Technical Service Bulletin

Cobra Motorcycle Mfg.

TSB1011 CX65 CDI unit

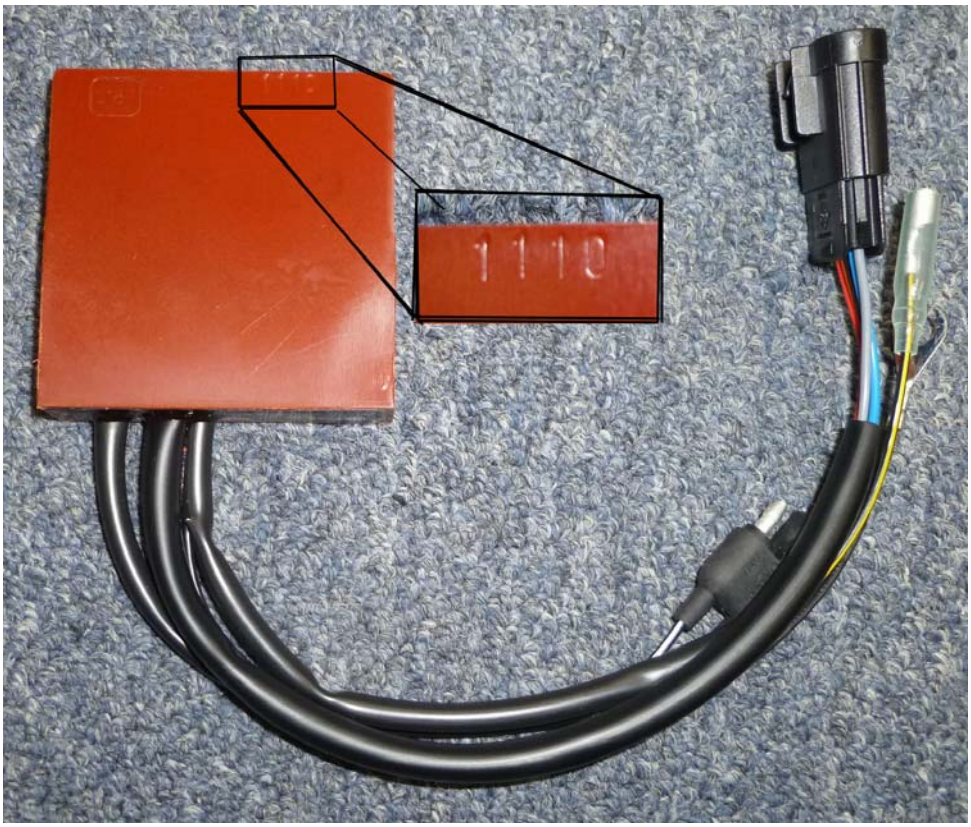
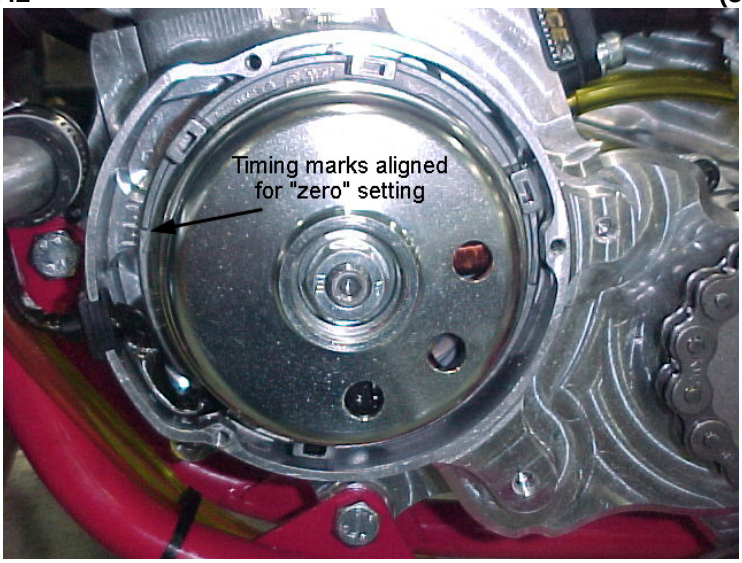
2011 Cobra CX65's are now shipping with an ignition CDI unit that allows the static base timing to be set at the "zero" timing point in the cases as opposed to the earlier units that had to be set at -5° retarded (CCW) from the "zero" timing point.

CDI units with a date code of 1110 (11/10, November 2010) or newer will require this advanced static timing. The date code is located at the upper right corner of the CDI unit which is located behind the front number plate.

NOTE: The date code is on the surface of the CDI unit that does NOT have the PVL sticker which means it is facing away from you when you pull the number plate off.
